# PLANNING COMMISSION MEETING AGENDA REGULAR MEETING

**November 13, 2012**

SUBJECT: PRELIMINARY SITE PLAN REVIEW – Proposed Beachview Estates Site Condominium, 10 units/lots, West side of Beach Road, 1000' South of Long Lake, Section 18, Currently Zoned R-1A (One Family Residential) District

SUBJECT: PRELIMINARY SITE PLAN REVIEW – Proposed Timbercrest Preserves Site Condominium, 14 units/lots, West of Dequindre, South of Wattles, West side of Fernleigh Drive, Section 24, Currently Zoned R-1C (One Family Residential) District

ORIGINAL ISSUE DATE: OCT. 12, 2012  
PEA JOB NO. 2011-150  
SCALE: 1" = 40'  
DRAWING NUMBER:  
**P-1**

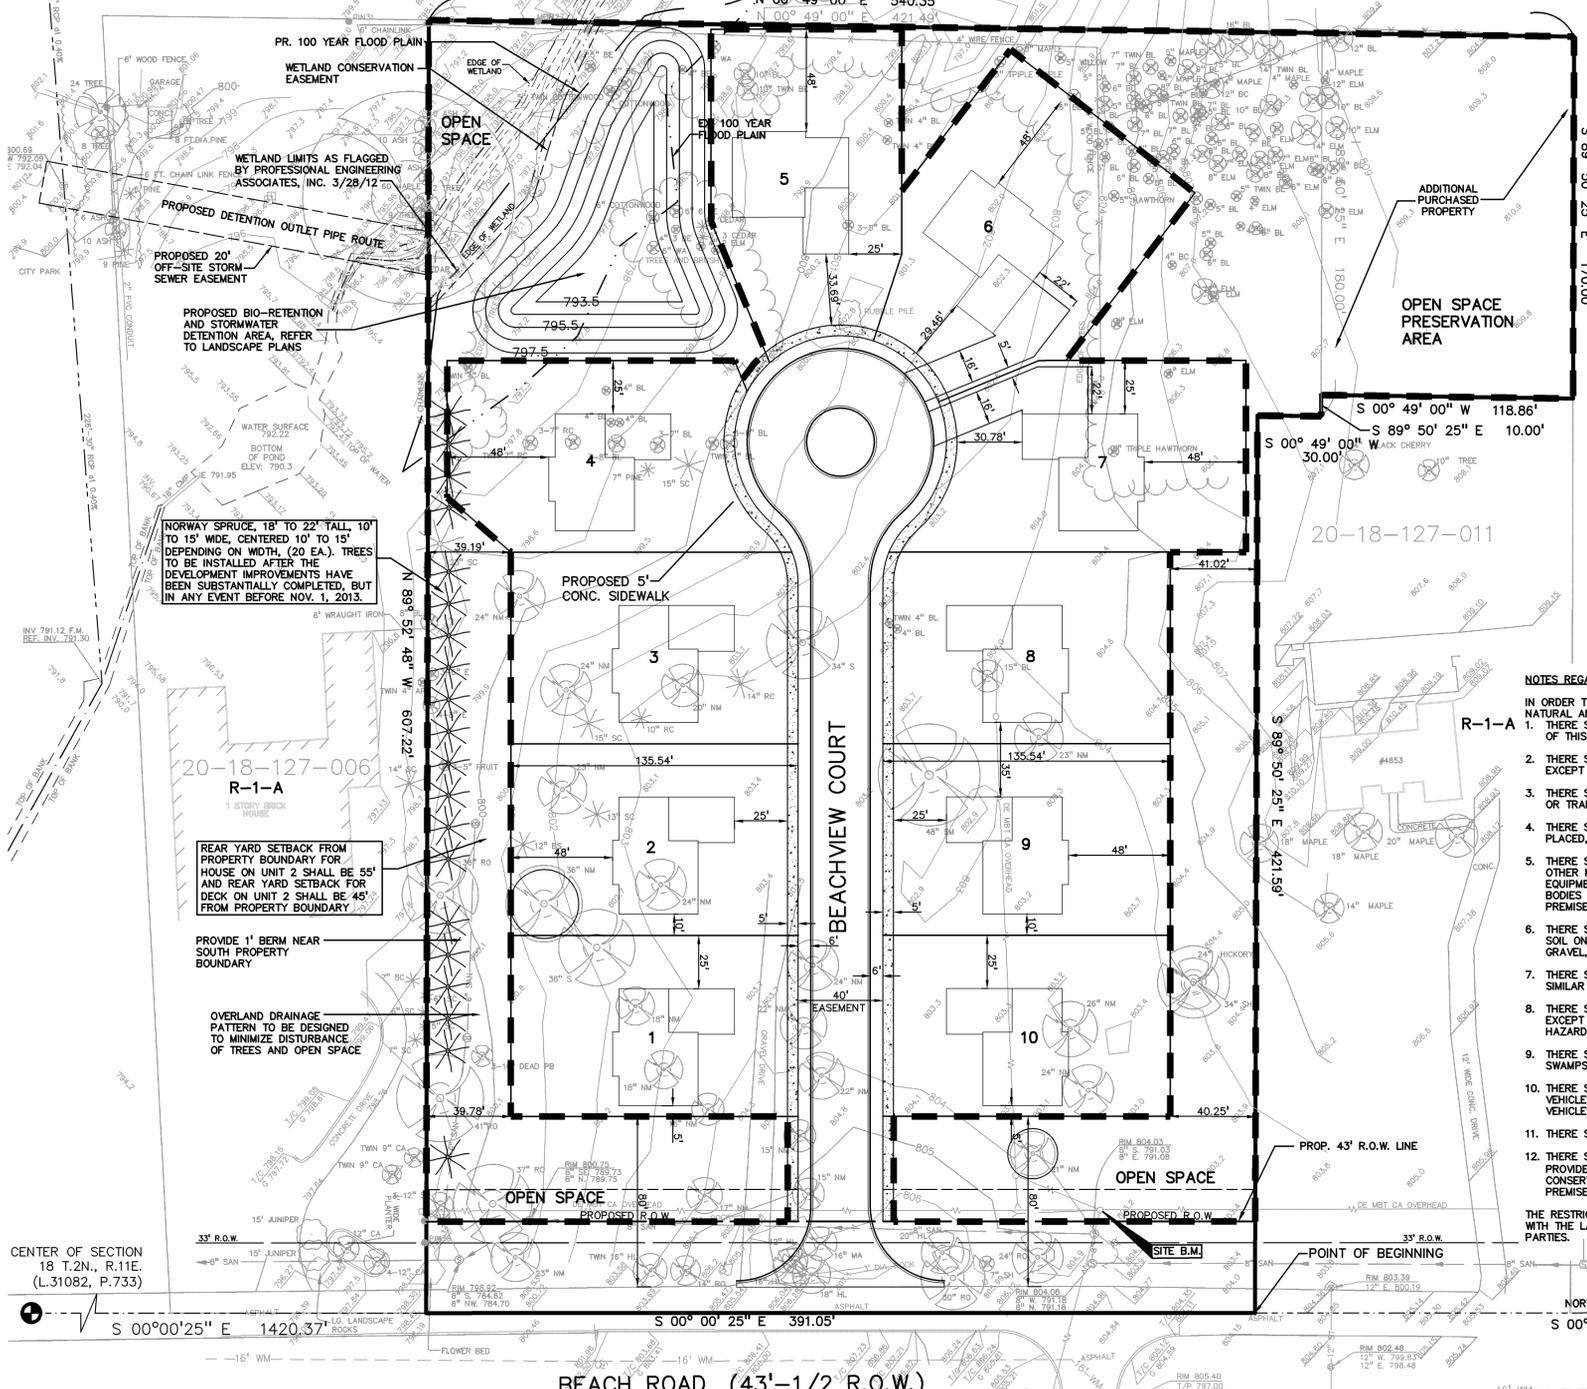
1. The applicant shall show and maintain the 25' x 25' corner clearance on both sides of the new intersection of Beachview Court and Beach Road.
2. An access drive to the detention basin will need to be provided.

The applicant is providing a 5-foot wide sidewalk along the entire length of the newly created Beachview Court; however has not shown a sidewalk along Beach Road. In previous submittals, the applicant did show a 5-foot wide sidewalk along Beach Road. The applicant should indicate if they are not proposing a sidewalk along Beach Road. If they are not providing a sidewalk they must seek a waiver from the Traffic Committee.

Though not required by ordinance, the applicant has shown the installation of twenty (20) Norway Spruces along the southern property line as part of an agreement with the adjacent property owner. The twenty (20) Norway Spruces are only shown on the Site Plan (Sheet P1) and should also be shown on the Landscape Plan.

**Items to be Addressed:** *Provide a 5-foot wide sidewalk along Beach Road or seek a waiver from the Traffic Committee.*

SHEET:  
**1** OF **3**  
MUNICIPAL REVIEW NUMBERS:

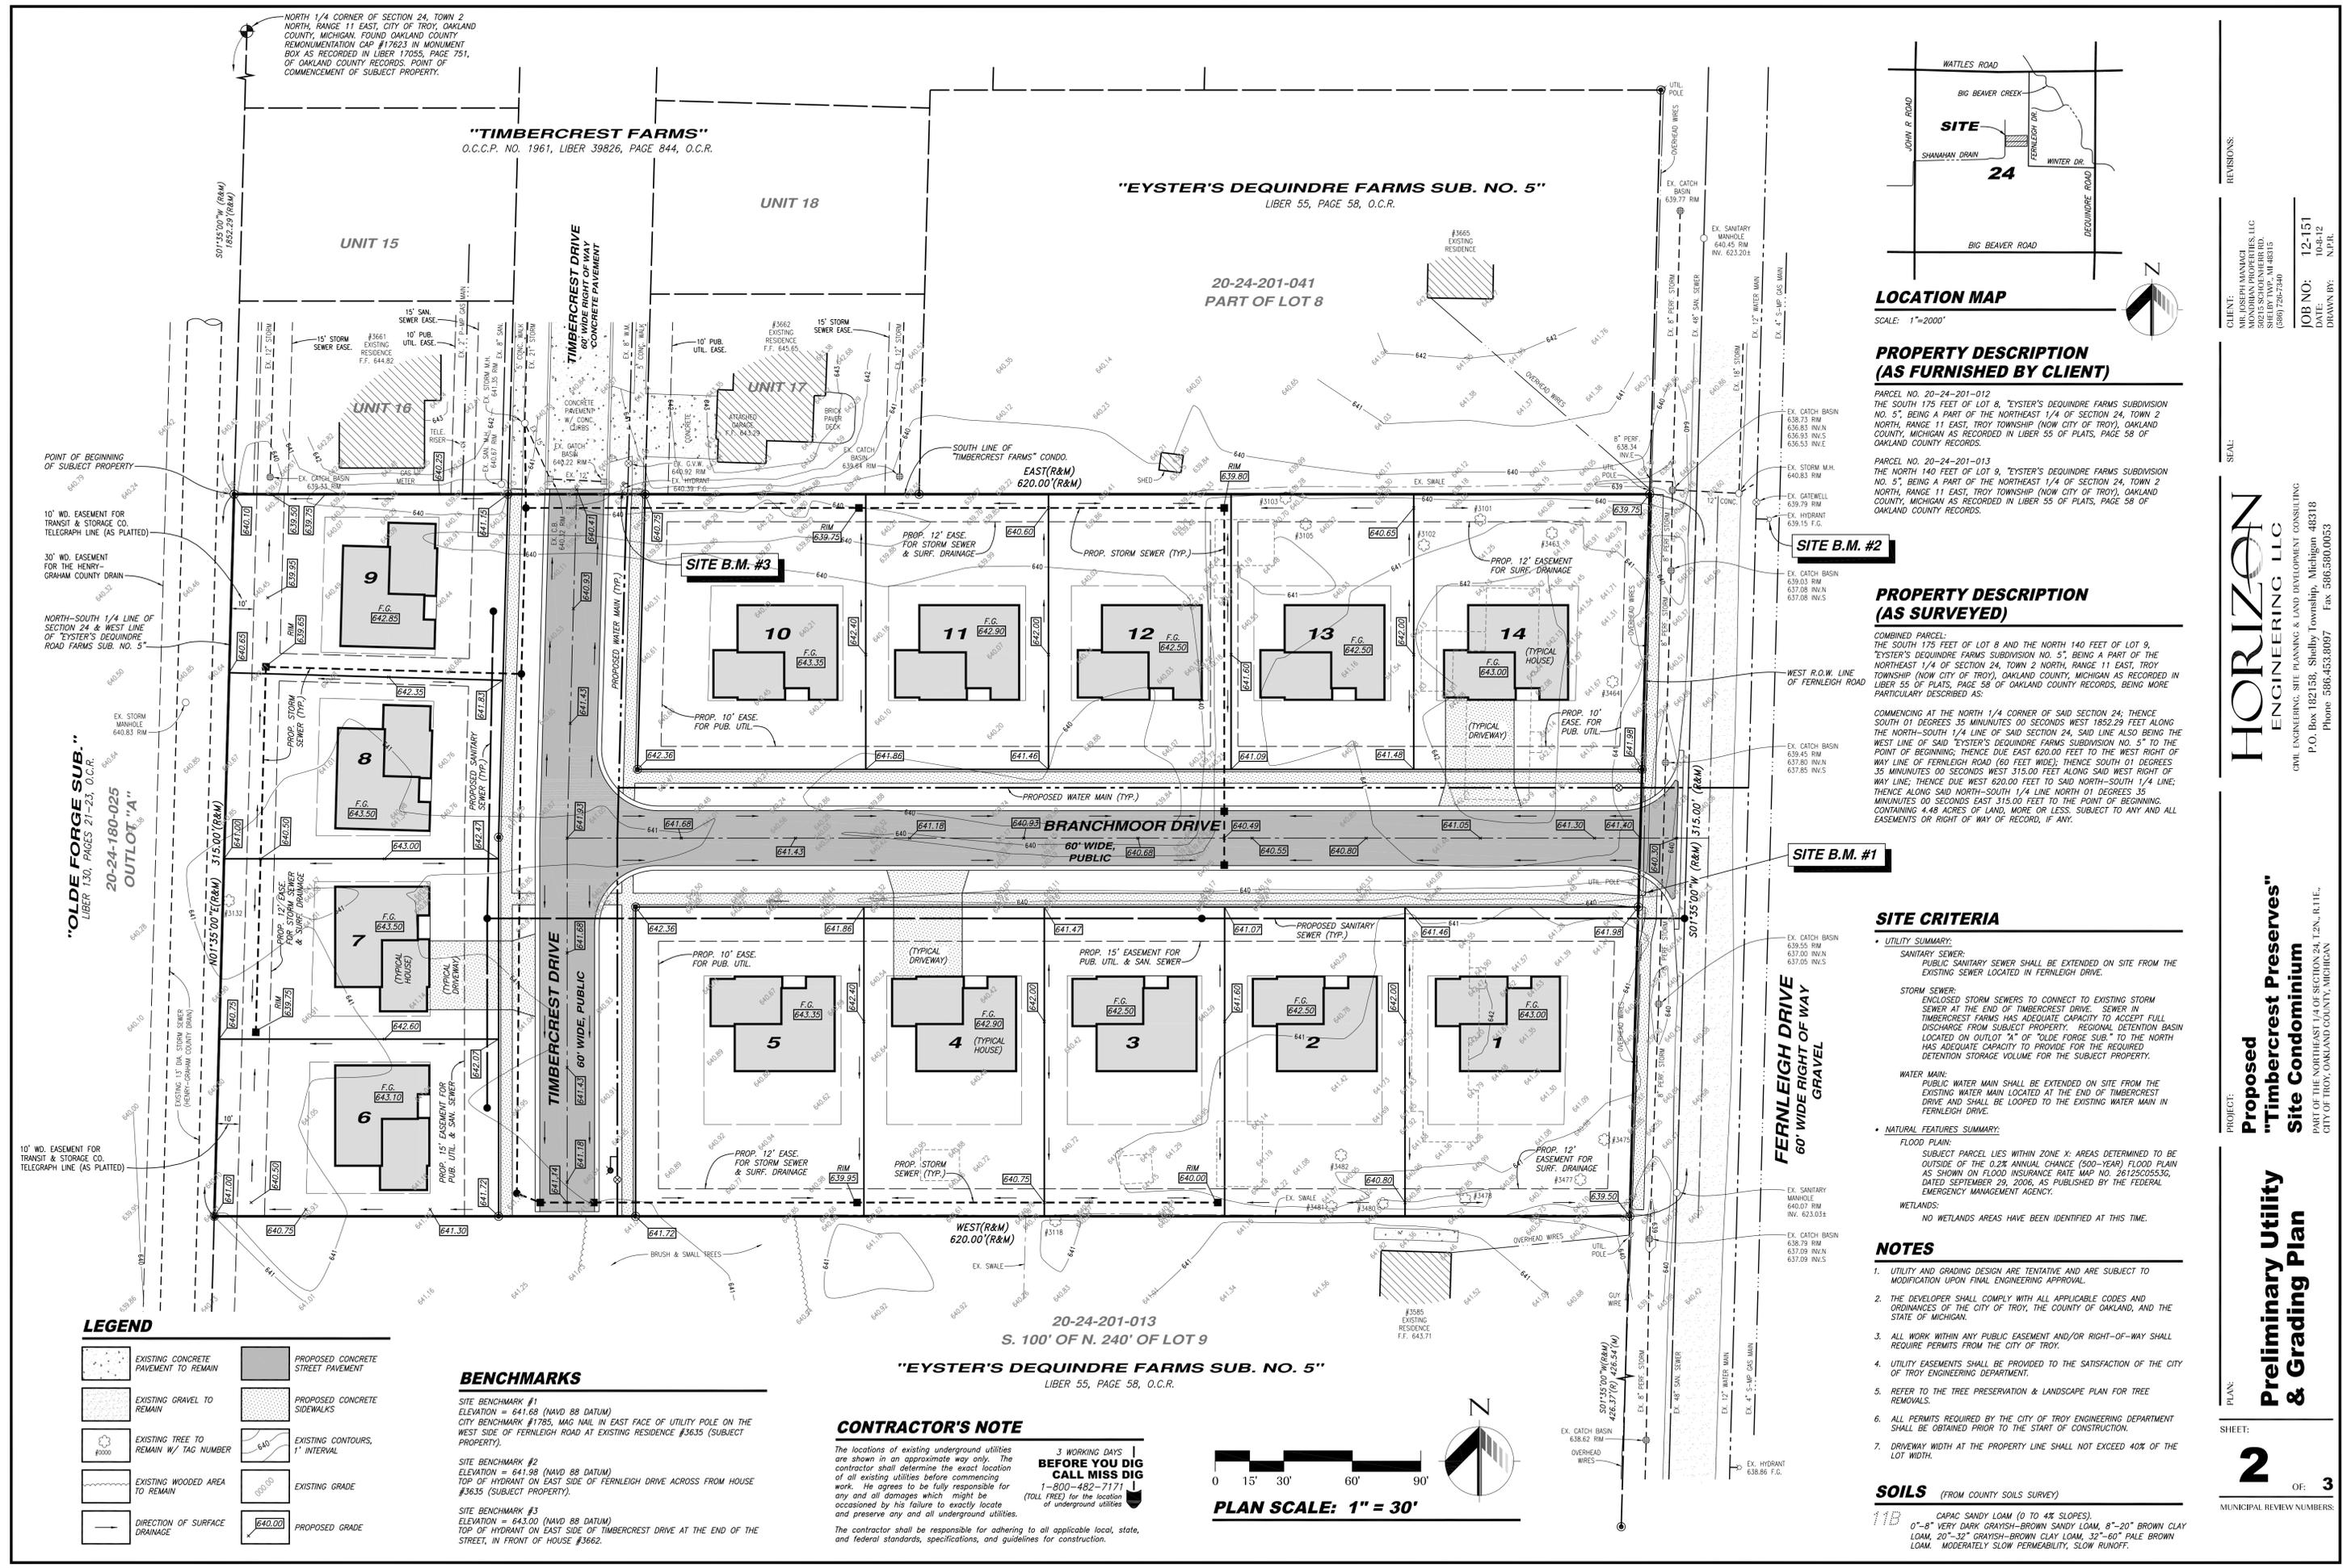
- A note should be added to Lot 7 stating that “driveway placement shall be on the south side of the lot so as to not impact the placement of the sidewalk ramp for pedestrian crossing of Timbercrest Drive”. There have been instances where sidewalk ramps lead to driveways on the opposite side. The developer should consider ramp locations relative to development of individual lots.

- Trees proposed at the corners of Branchmoor and Timbercrest (NE and SE corners) should be removed from the area of the 25’ x 25’ corner clearance triangles, extended. This would remove four (4) trees from the landscape plan (one each on the north and south side of Branchmoor and one each on the east side of Timbercrest, north and south of Branchmoor). These trees will need to be relocated.

1. *Indicate treatment of proposed Timbercrest Drive stub.*
2. *A note should be added to Lot 7 stating that "driveway placement shall be on the south side of the lot so as to not impact the placement of the sidewalk ramp for pedestrian crossing of Timbercrest Drive".*
3. *There should be a minimum of 2' from the face of the existing utility poles to the edge of sidewalk along Fernleigh Drive.*
4. *Relocate the four (4) trees that are proposed at the corners of Branchmoor and Timbercrest (NE and SE corners).*
